Access Compliance Report

Public Rights-of-Way (Curb Ramps)

Intersection ID: 13442	Main Street: MORRIS_FIELD_DR	Cross Street: AIRPORT_CENTER_PY	Location: NE
ADA ID: 783B81861287	Ramp Type: Perp	Initial Pass/Fail: Fail	Overall Compliance: No
Severity Score: 21.25			
Codes/Mitigation Info/Possible Solution		Field Measurements/Component Compliance

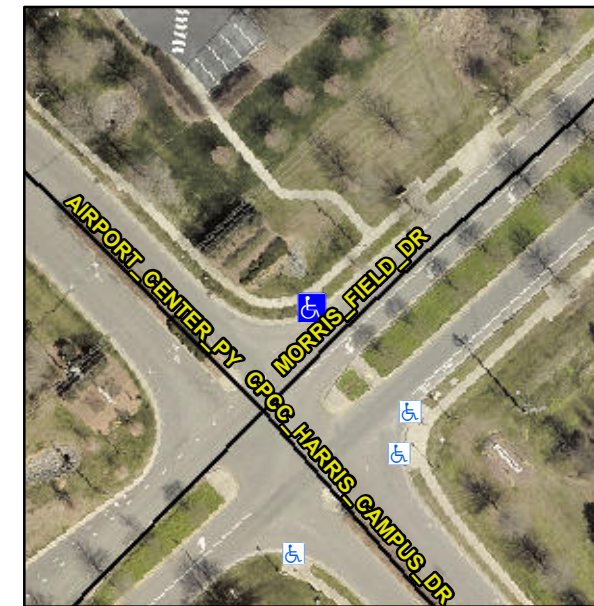
Not Found, R304.5.1, R304.2.2

Compliance	Description	Data	Compliance	Description	Data
N/A	Ramp Length (in)	71.0	No	Ramp Slope (%)	8.8
No	Ramp Width (in)	47.0	Yes	Ramp XSlope (%)	0.3
N/A	Flare Type LT	N/A	N/A	Flare Type RT	N/A
N/A	Flare Slope LT (%)	N/A	N/A	Flare Slope RT (%)	N/A
N/A	Flare Traversable LT?	N/A	N/A	Flare Traversable RT?	N/A
N/A	Landing Length (in)	N/A	N/A	DWS Provided?	N/A
N/A	Landing Width (in)	N/A	N/A	DWS Contrast?	N/A
N/A	Landing Slope (%)	N/A	N/A	DWS Length (in)	N/A
N/A	Landing X Slope (%)	N/A	N/A	DWS Full Width?	N/A
N/A	Landing Curb? (Y/N)	N/A	N/A	DWS Offset (in)	N/A
N/A	Shared Landing?	N/A			
N/A	Gutter Ponding?	N/A	N/A	Gutter Slope (%)	N/A
N/A	Gutter Lip Ht (in)	N/A	N/A	Gutter X Slope (%)	N/A
N/A	Painted X Walk1?	No	N/A	Painted X Walk2?	N/A
	X Walk 1 Direction	To SE		X Walk 2 Direction	N/A
N/A	X Walk 1 Width (in)	N/A	N/A	X Walk 2 Width (in)	N/A
	X Walk 1 Slope (%)	2.7		X Walk 2 Slope (%)	N/A
	X Walk 1 X Slope (%)	2.1		X Walk 2 X Slope (%)	N/A

Remove & Replace Entire Ramp.
